Abutters to Squibnocket Project  
Chilmark, MA. 02535

February 3, 2016

Mr. Paul Foley  
Land Use Planning Committee (LUPC)  
Martha's Vineyard Commission  
P.O. Box 1447  
Oak Bluffs, Massachusetts. 02557

## Overview of Height of Causeway – Current Proposal

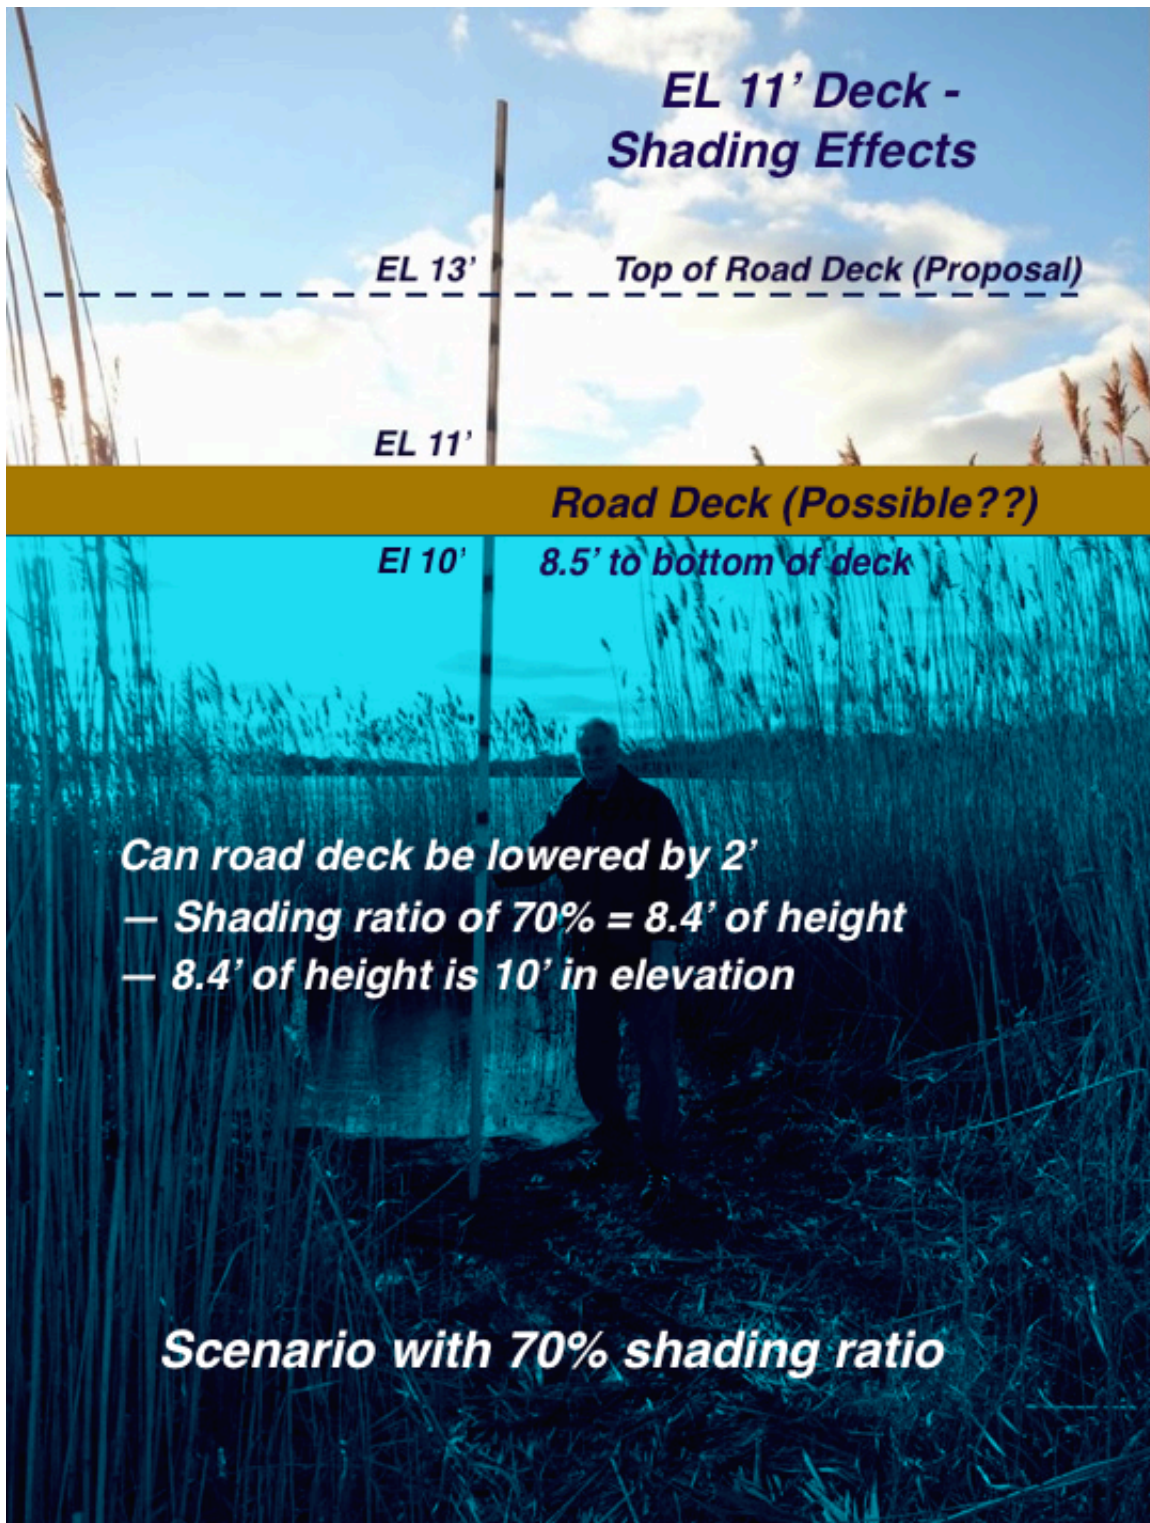
Most important from the abutters perspective is the mass and overall scale of the causeway. The current proposal calls for a 13' structure (elevation to the top of the road deck). The effect across grade is an average height at the top of the deck of 11.5' above the terrain for 240' across the wetland. And, as currently planned, the railing adds another 4' of dense wooden fencing along the entire bridge from end-to-end. This has the practical effect of creating a 15.5' high causeway structure with an elevation of 17'.

- Batter board is marked in 1' increments
- Batter board is on grade at an elevation of 1.5' NAVD88 (Lidar topo – 2010)
- Dotted line shows the top of the road deck in the current SFHA proposal

- Reducing the elevation by as much as 2’. This is technically possible and would reduce the *height over grade* from 11.5’ to 9.5’ (‘elevation’ would be reduced from 13’ to 11’). This is a reduction in height over grade of 17%. (See pages 5-10 for the technical details).
- Changing the guardrail from the heavy rustic design to a lighter, lower guardrail system. It would be preferable to have steel posts with wires. A second possibility is a standard guardrail. In both cases, it does not need to be any higher than 2’ including the curb. It should also be noted that the model for this causeway as proposed by the Selectmen was the Menemsha causeway, which has a very light railing. (See page 11).

## Height Measurement for Shading Analysis

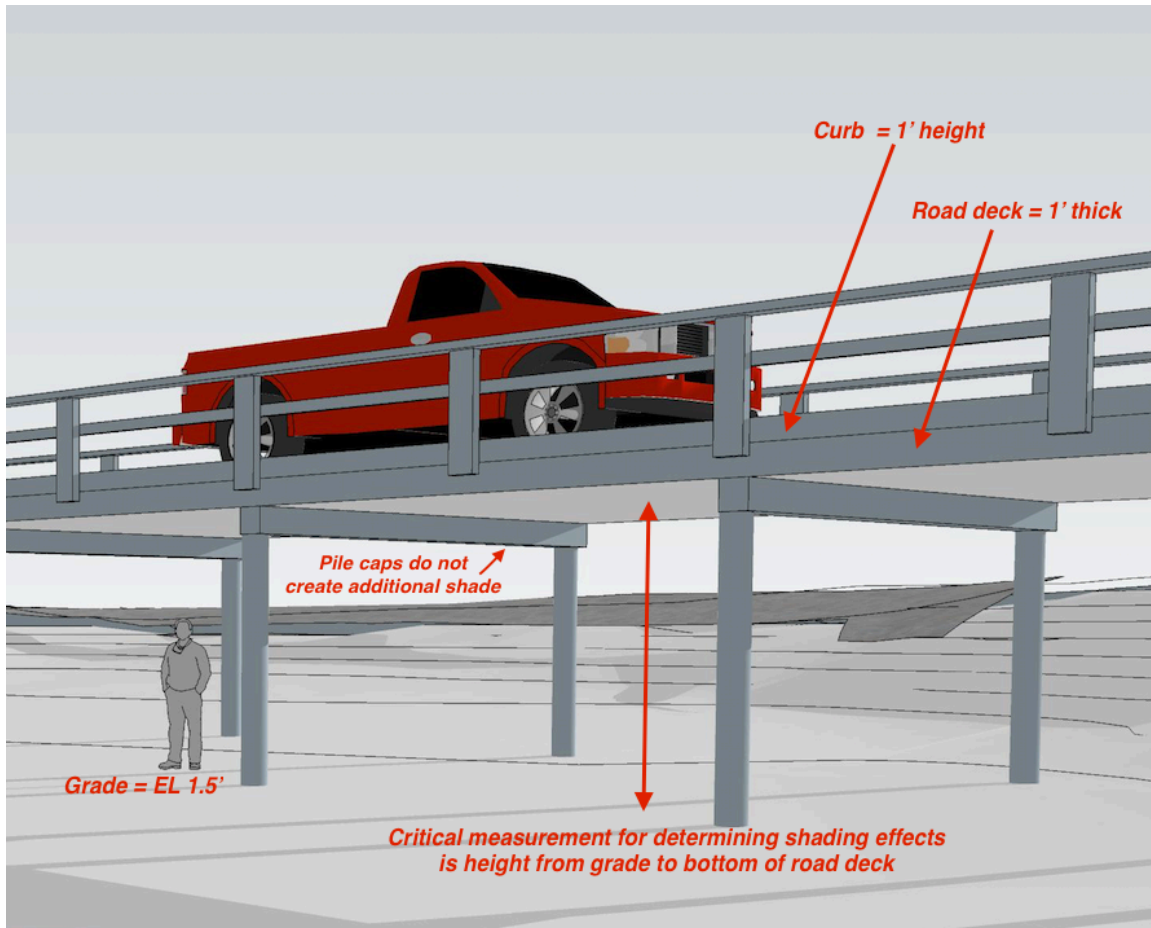
- 70% shading guideline requires 8.4' of clearance to bottom of deck
- 70% is minimum allowable in North Carolina DOT study
- Additional mitigation is possible by reducing the width of causeway to 11'; only 7.7' would be required (10" additional clearance beyond requirement)

- The critical measurement for determining shading effects is the height from grade to the bottom of the road deck. It is the road deck that causes the shading.
- Based on the NC DOT guideline to determine height above grade for shading mitigation, 70% of the width of the proposed causeway is necessary from grade to bottom of road deck to mitigate shading effects ( $12' \text{ width} \times 0.7 = 8.4'$ ). If 8.4' is used as necessary 'height from grade', the bridge can be lowered by 2' without having a negative effect on the underlying vegetation.
- Alternatively, if the width of the causeway were reduced by 1' to 11', we would gain additional flexibility. ( $11' \text{ width} \times 0.7 = 7.7'$ .) While we would not recommend reducing the elevation by more than two feet, reducing the width of the causeway would provide additional shading mitigation.

## Flooding/Hydraulics

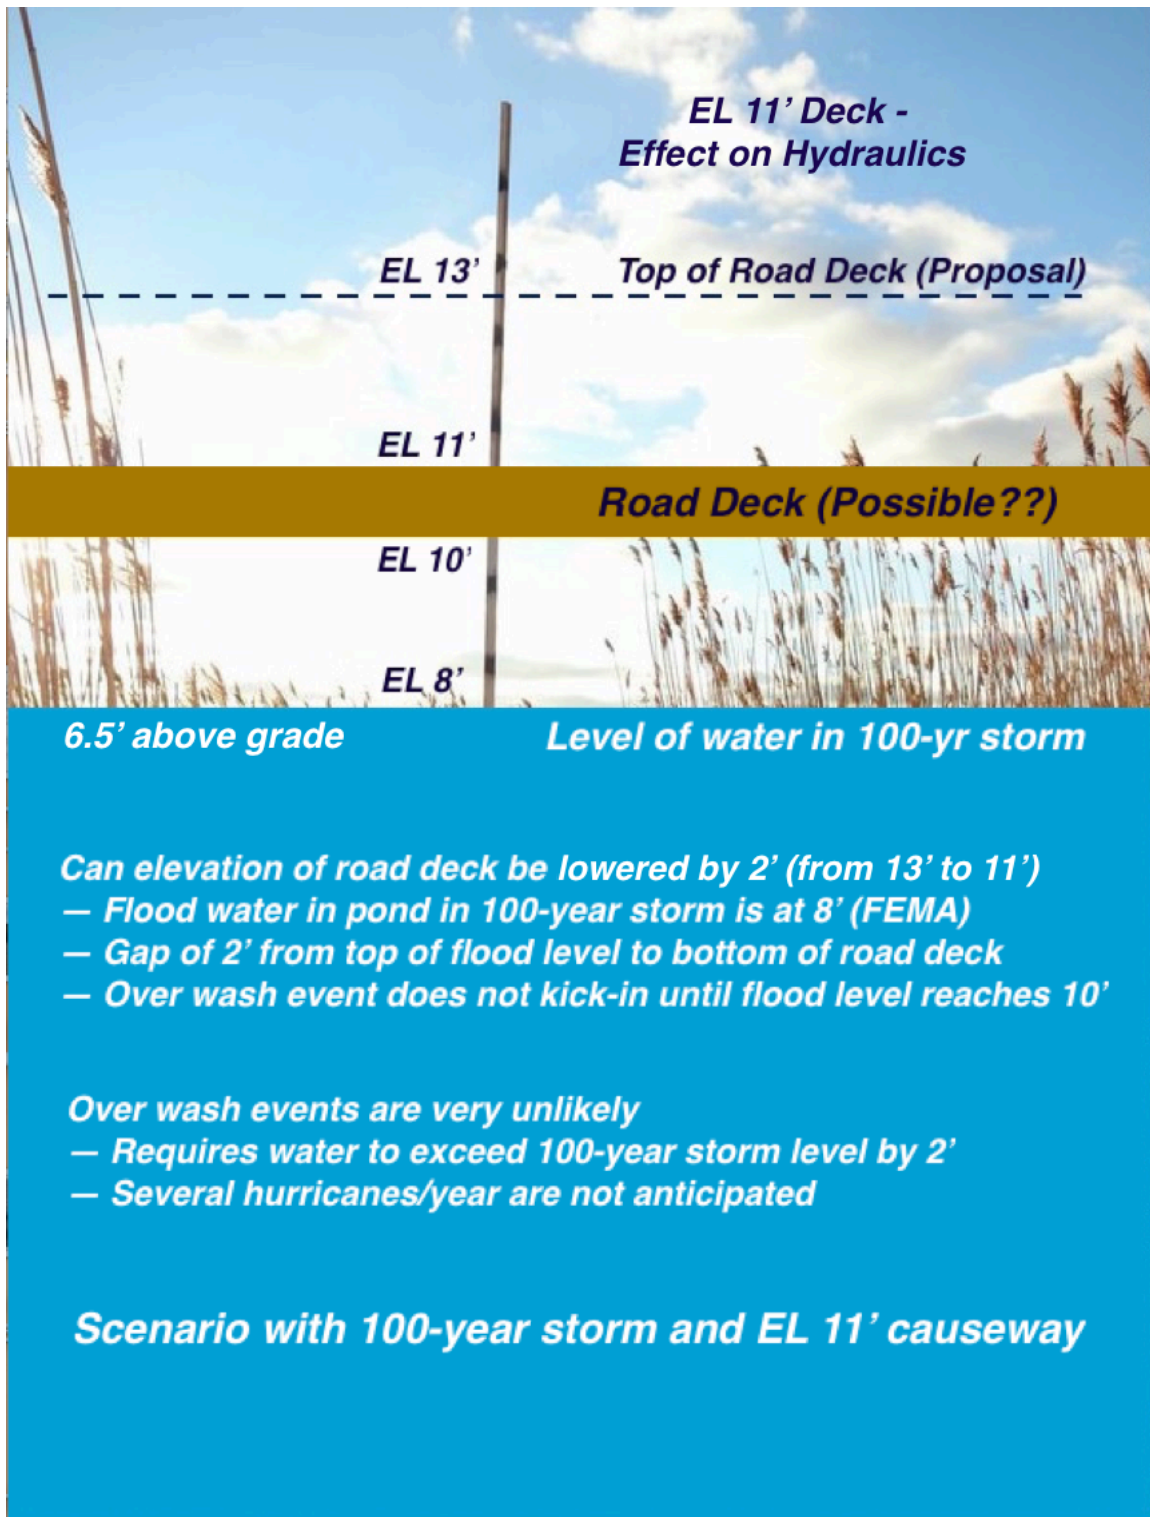
- Water level can be at EL 10' before it touches the bottom of the deck
- This 2' above the level for the 100-yr storm in the H & A documentation

**Causeway Railing:** Existing railing adds significant mass to structure.

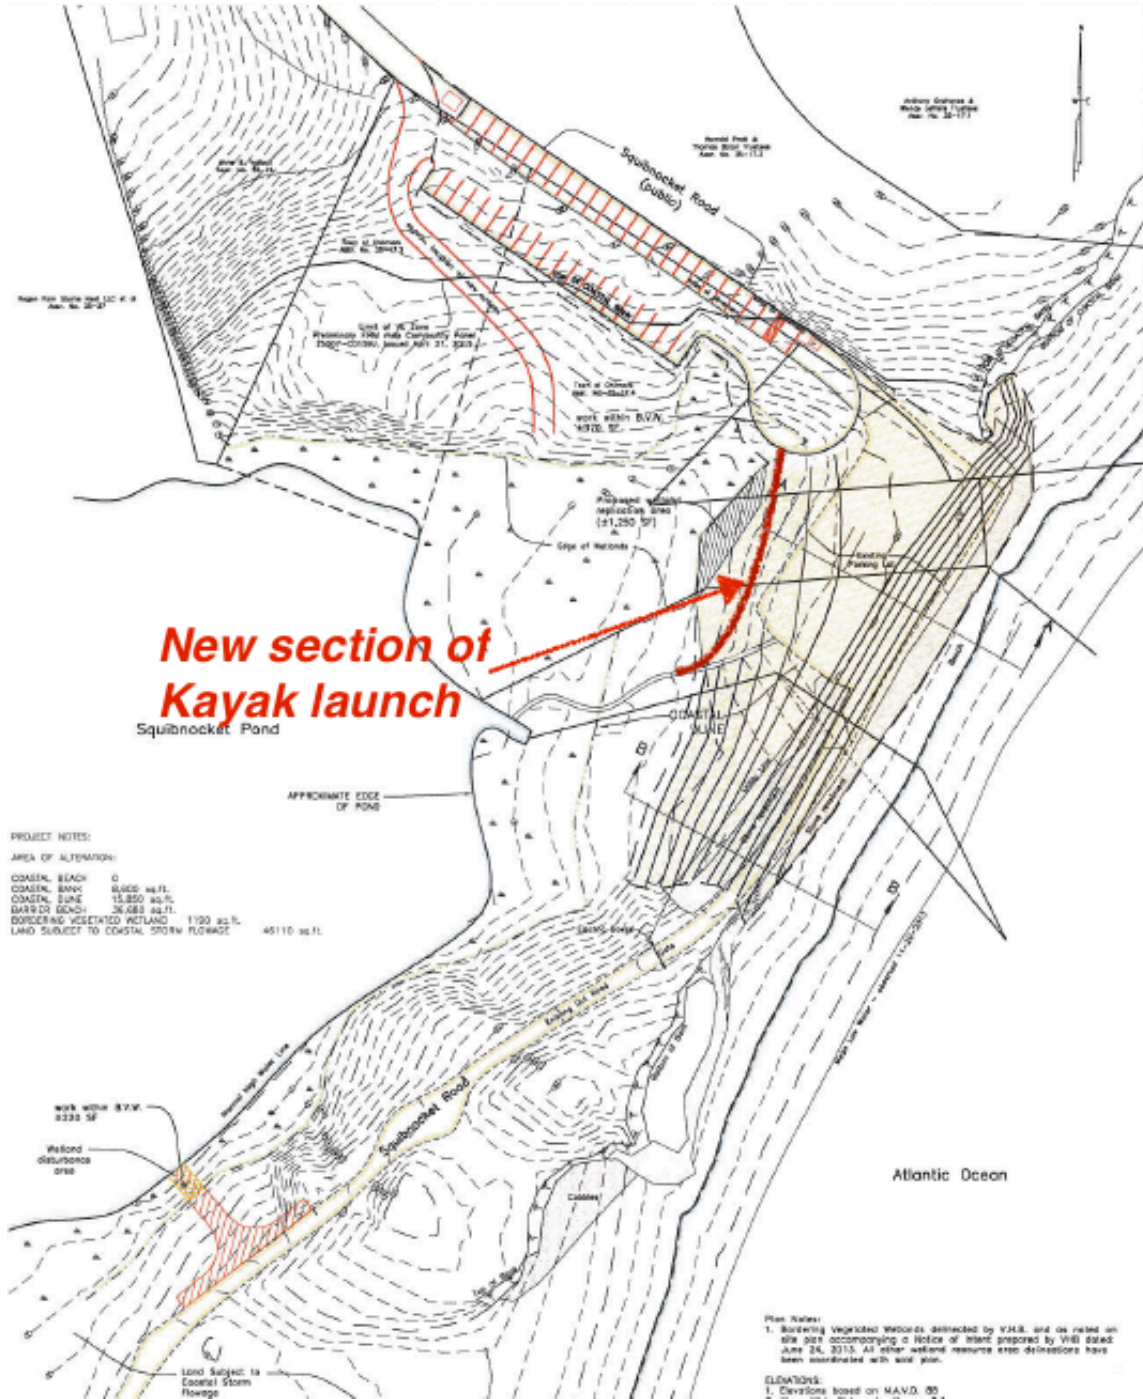
Menemsha railing on new causeway is lighter, more 'see through, and less obtrusive.

## Existing Boat Launch Access (Extension Connects To It)

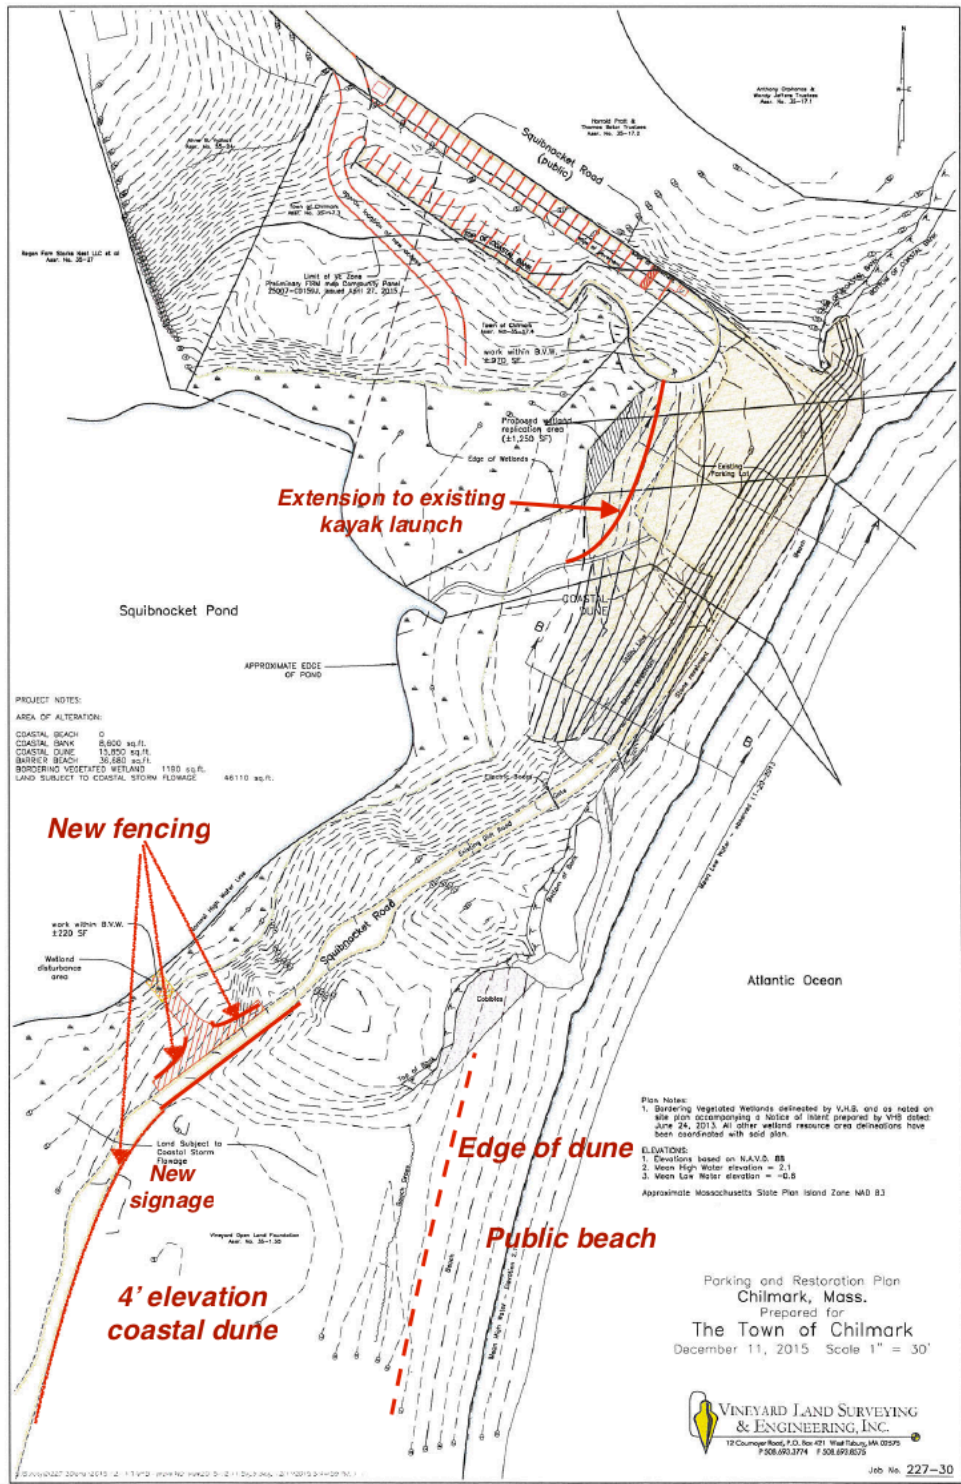
**Boat Access -- Kayak launch:** existing launch could be extended and connected to the turnaround

- New path to existing access would provide a convenient launch point

- Existing access is an improved road that was built after Hurricane Bob
